Summary of Changes

Old Wood Energy Park Appeal

Rushcliffe Borough Council App Ref:
24/00161/FUL

Date: October 2025

Figure 1 – Summary of Changes

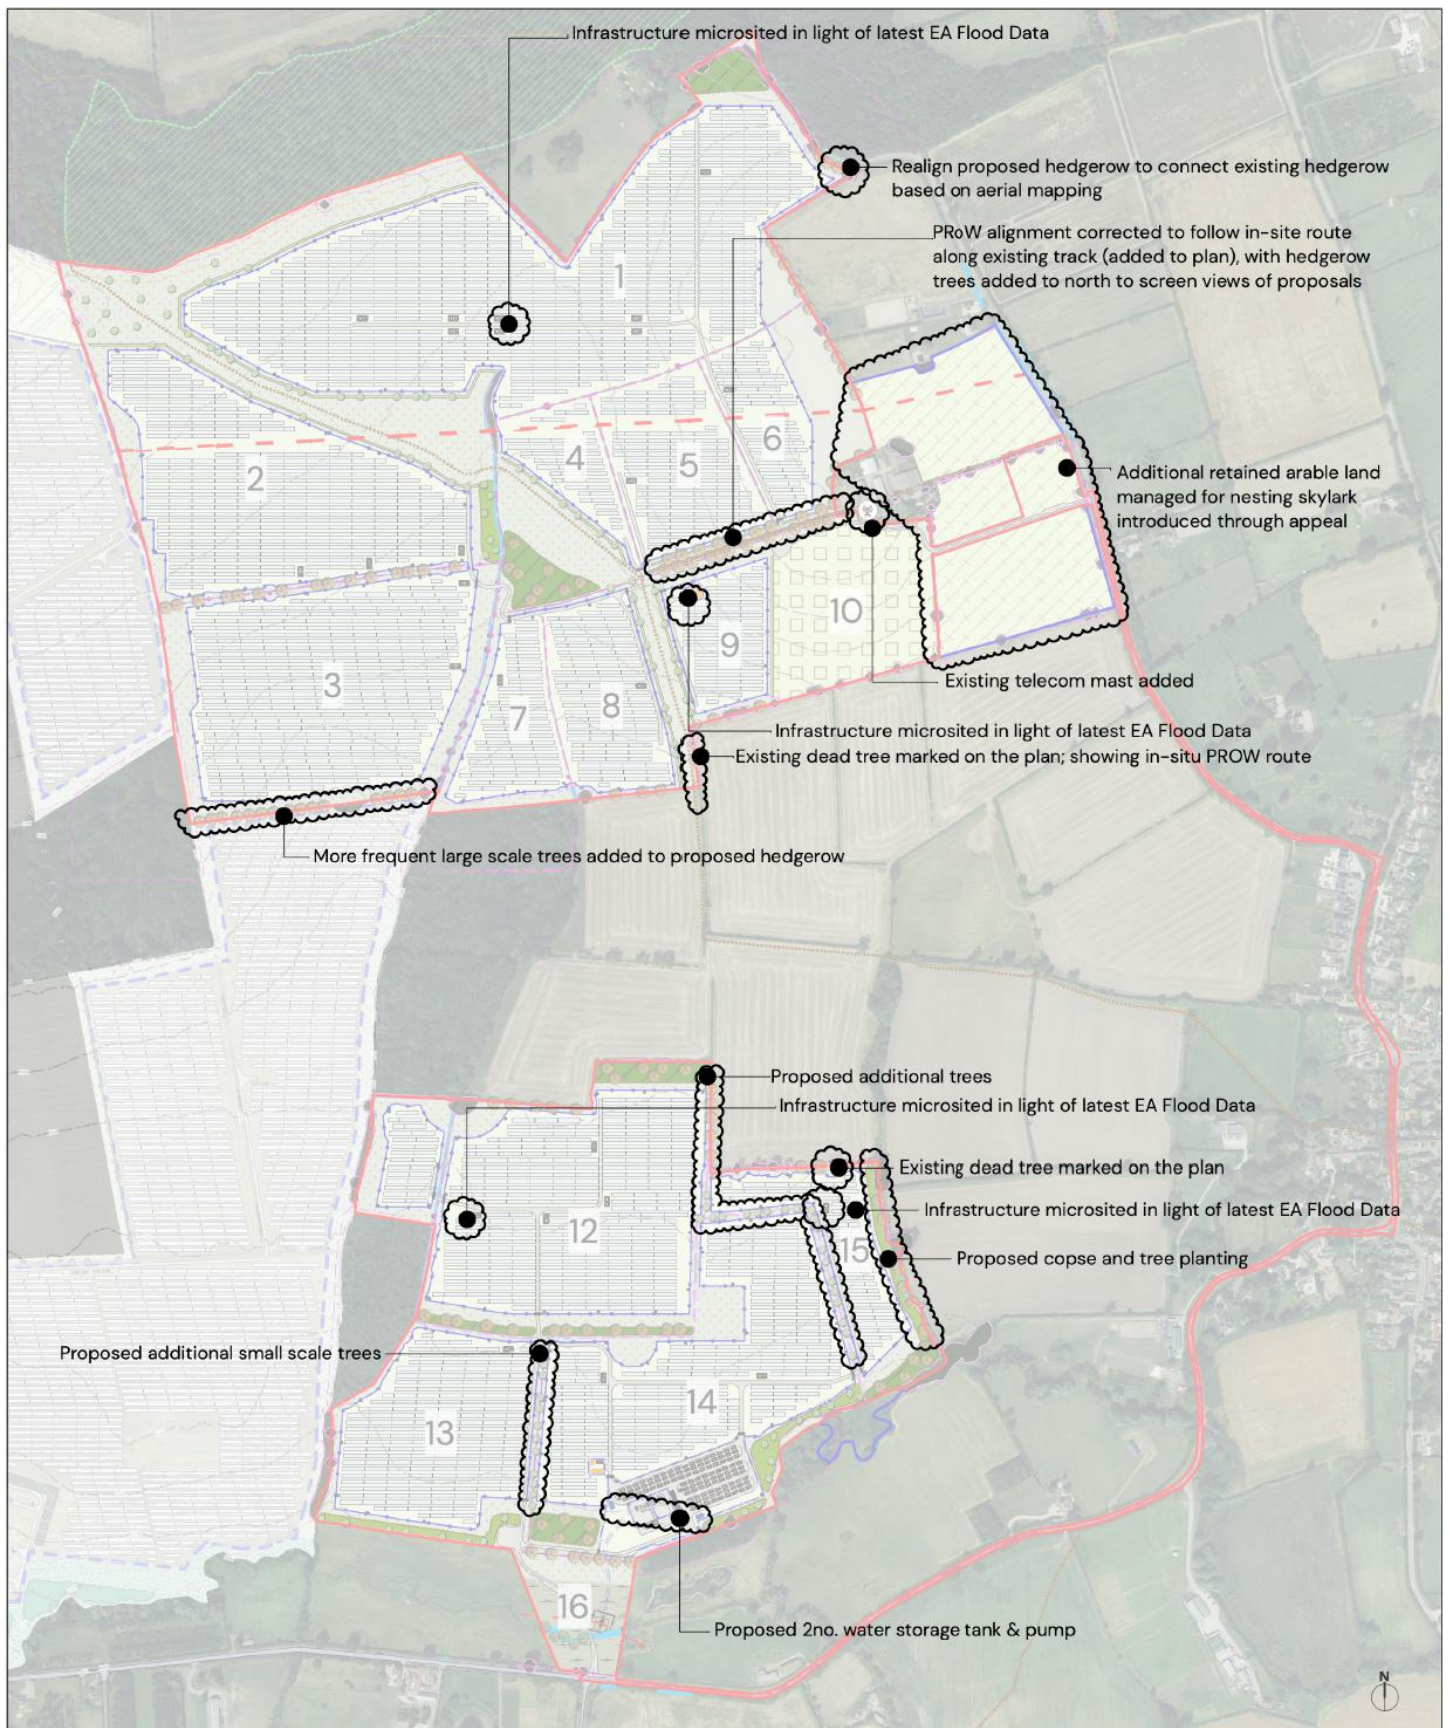
- Re-location of some electrically sensitive/ vulnerable solar farm infrastructure in a number of isolated locations in response to the latest surface water flooding data published by the Environment Agency in March 2025. These have typically been micro-sited within 10-20 m in most cases to avoid potential areas of shallow surface water flooding. Specifically this includes 2 inverters towards the centre of field 1 which have moved west, the connection compound in field 9 which has moved northeast, an inverter in the west of field 12 which has been rotated 90 degrees and moved east and an inverter in field 15 which has been rotated 90 degrees and moved fractionally east. These changes have resulted in the loss of 72 solar panels.

- Provision of two dedicated above ground Fire Water Storage Tanks at the BESS compound;
- Inclusion of additional retained arable land managed for nesting skylark in fields to the east of fields 6 and 10 towards Bradmore Road. This land is outside the planning application boundary but within land under the control of the Applicant which has been shown by a blue line added to the Enhanced Landscape Strategy Plan.

- A number of changes with regards to landscape mitigation enhancement (further detail included in the Landscape Hearing Statement) but generally additional hedgerow, hedgerow trees or woodland copses and the alignment of a public right of way south of fields 5 and 6 was corrected to follow the definitive route and the route on-site, which is along the existing track. In addition a section of internal access track south of fields 5 and 6 was removed and access to field 6 is now proposed by a crossing of the footpath using existing gaps in the hedgerow.

Figure 2a – Inverter re-location Field 2

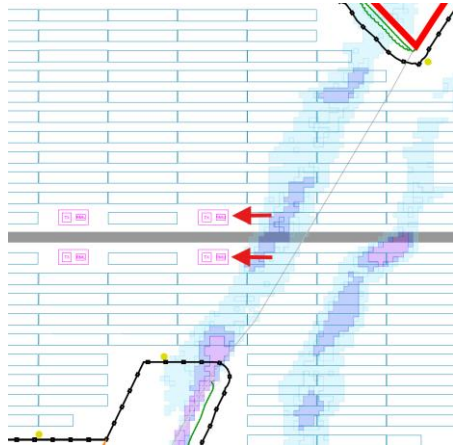
Two field inverters have been moved slightly further west in the centre of field 1. By swapping the two inverters with two tables of solar panels the inverters are now outside the flood extent and whilst the solar panels are in the flood extent the depth of flooding is substantially below the lower end of the panels such that they remain above any flood water. The red arrows show the direction the two inverters have moved.

Figure 2b – Solar connection compound re-location Field 9

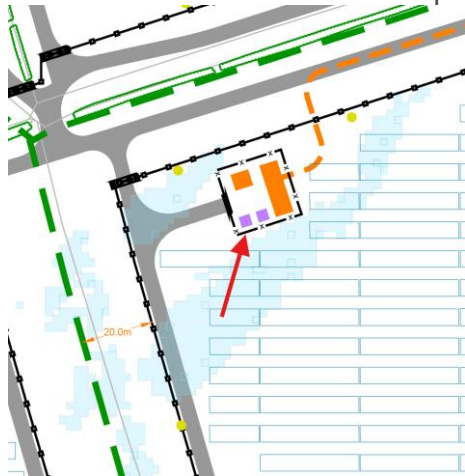
The solar connection compound in field 9 has been relocated slightly northeast removing some solar panels. Part of the area previously covered by the compound has been replaced with some solar panels. The revised location ensures the compound and its electrically sensitive/ vulnerable equipment is outside any modelled flood extent. The red arrow shows the direction the compound has moved.

Figure 2c – Inverter re-location Field 12

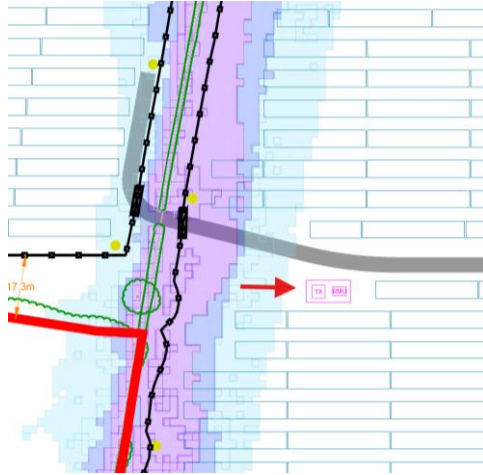
One field inverter has been rotated 90 degrees and moved slightly further east in the west of field 12. The relocation of the inverter has resulted in the loss of a table of solar panels but the inverter is now outside the flood extent. The red arrows show the direction the inverter has moved.

Figure 2d – Inverter re-location Field 15

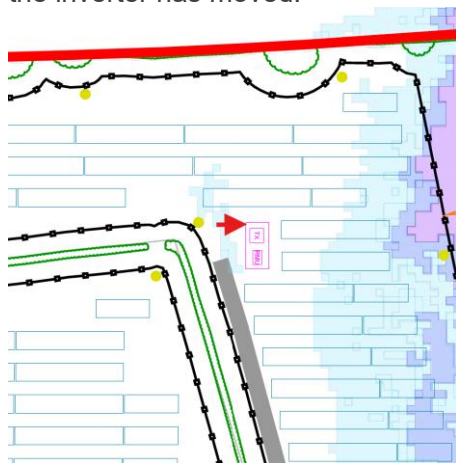
One field inverter has been rotated 90 degrees and moved slightly further east in the east of field 15. The relocation of the inverter has resulted in the loss of a half table of solar panels but the inverter is now outside the flood extent. The red arrow shows the direction the inverter has moved.

Figure 3 – Water Tank Locations

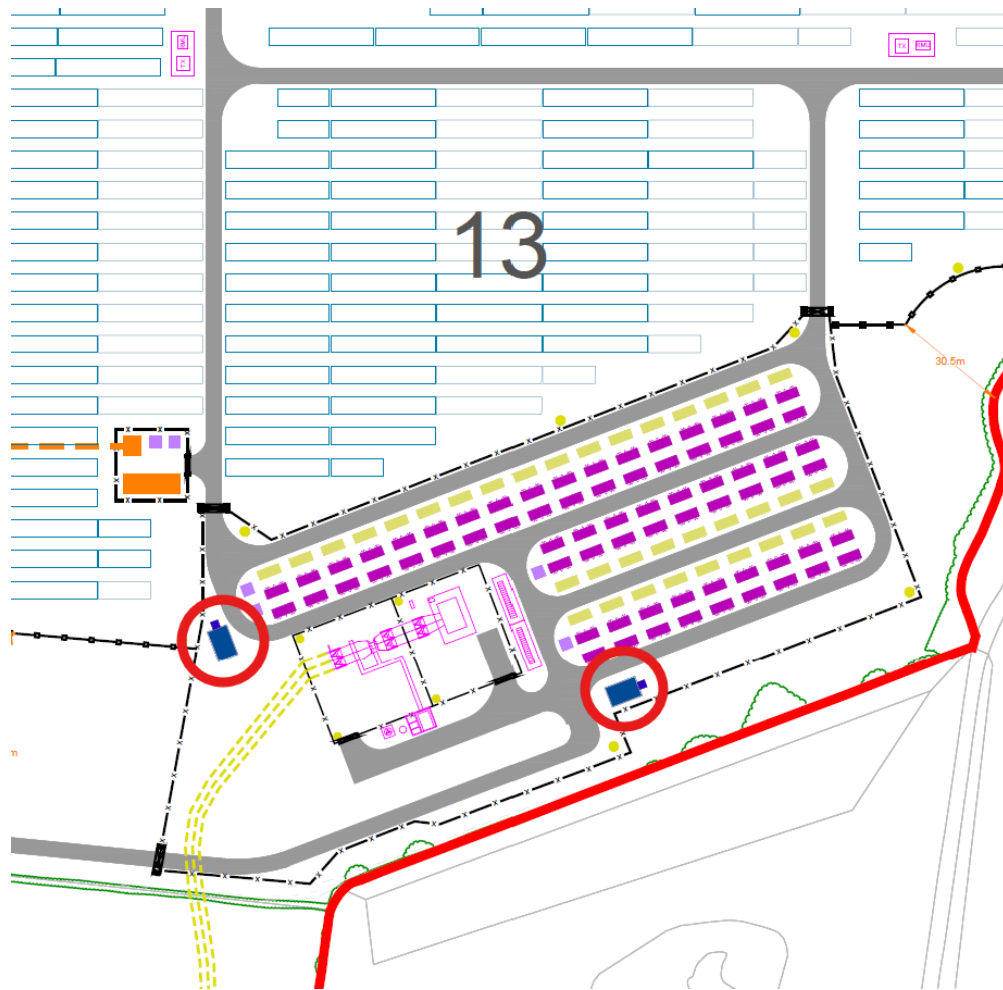
However to mitigate any potential concerns the fire service may have with recycling fire water, and to maintain a flexible design, two above ground water tanks with associated pump housing are now included on the site layout plan, as shown the extract below (ringed

in red). The tanks have the following dimensions – 8 m x 5 m x 3 m (h) with a small adjoining housing for a pump of 2 m x 2 m x 2 m.

Each tank (shown as blue rectangular boxes with small squares on an end on Figure 3), would have a capacity of circa 120,000 litres so together water capacity of 240,000 litres. The NFCC guidance requires a minimum of 1,900 litres per minute for 2 hours, totalling 228,000 litres. The pump houses allow for water to be pumped into and out of the tanks.

The inclusion of the water tanks ensures that adequate supplies of fire water are stored on site, in compliance with the requirements of the NFCC guidance. Having two tanks in the locations they are proposed provides sufficient water capacity and ensures that fire fighters have a water supply within 120 m (two 60 m hoses joined together, not requiring a further pump) of all BESS units.

Figure 5

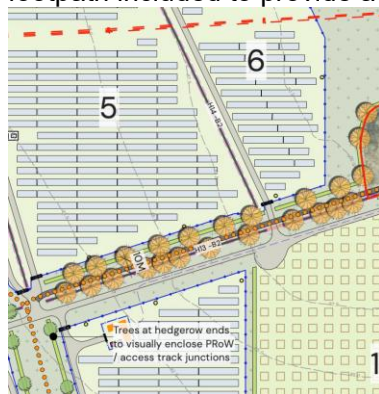
- Public Right of Way alignment corrected to follow the definitive route and on-site route along the existing track, with hedgerow and hedgerow trees added to the north to screen views in fields 5 and 6. Because of this change a section of internal access track south of fields 5 and 6 was removed and instead a crossing of the footpath included to provide access into field 6. See Figure 5.

Figure 6

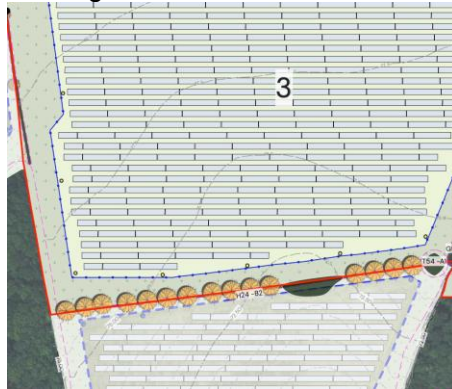
- More frequent large scale trees added to the proposed hedgerow south of field 3. See Figure 6.
